ALERT SERVICE BULLETIN

NO. 222-01-89

MODEL AFFECTED: Model 222 and 222B

SUBJECT: UPPER FUEL ENCLOSURE, RIGHT SIDE
ADDITION OF DRAIN PROVISION

FIGURE 1

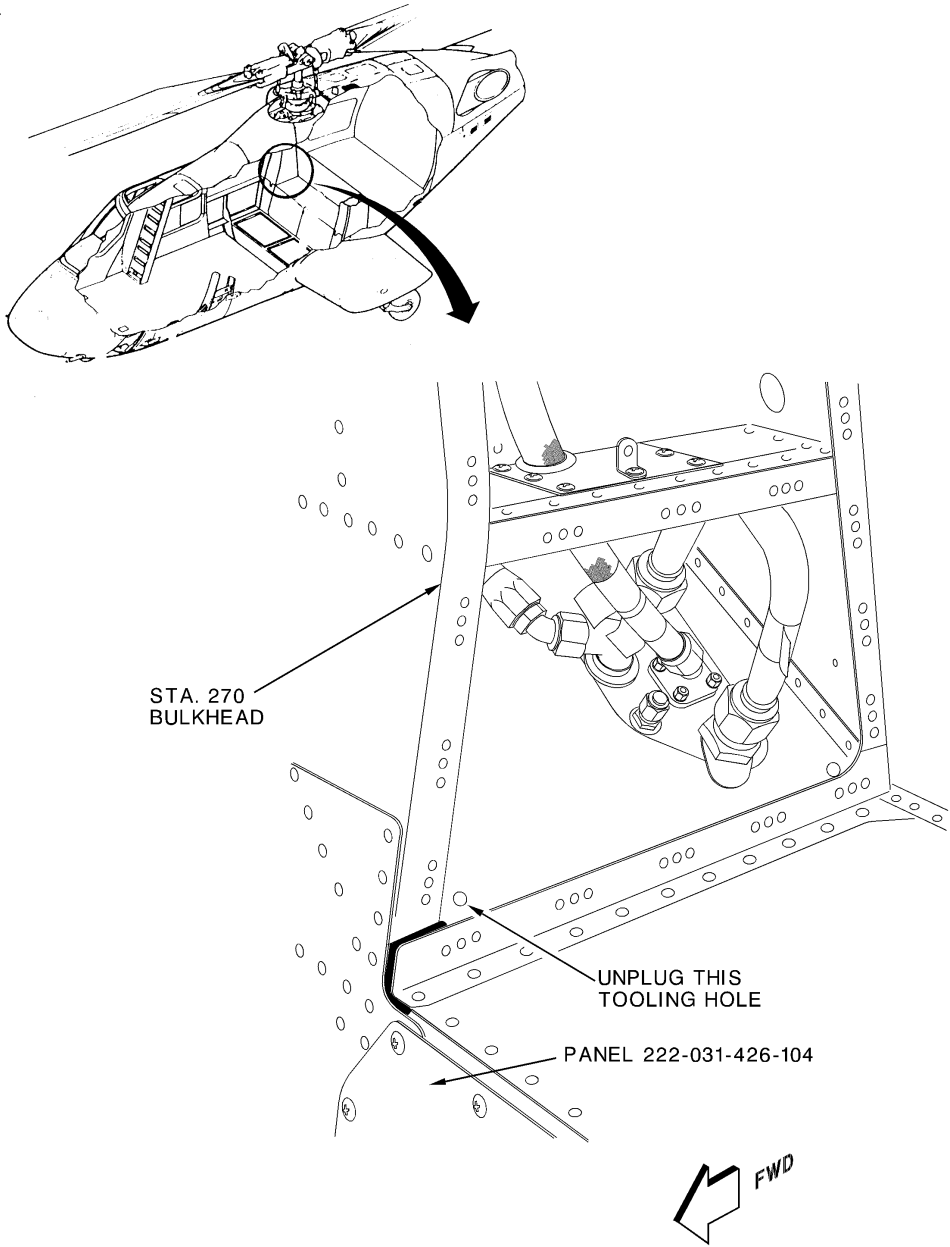
This bulletin provides the procedures to remove the sealant from the existing forward tooling hole located in panel assembly P/N 222-031-470-103 to provide enclosure drainage provision.

Tooling hole is located at approximate STA 271.00, B.L. 22.25, W.L. 54.00 in panel assembly P/N 222-031-470-103

5. Locate forward tooling hole in panel assembly P/N 222-031-470-103 and unplug hole using a plastic scrapper and a pin punch or a similar object. Refer to Figure 1.
6. Reposition fuel cell upper right hand side into airframe cavity.
7. Install access panel P/N 222-031-426-104 with sealant MIL-S-8784CLB2. Refer to BHT-222/222B-MM-1, chapter 53.
8. Install the seat cushions and seat backs on the rear passenger seats. Refer to BHT-222/222B-MM-1, chapter 25.
9. Annotate helicopter records to reflect compliance with this bulletin.
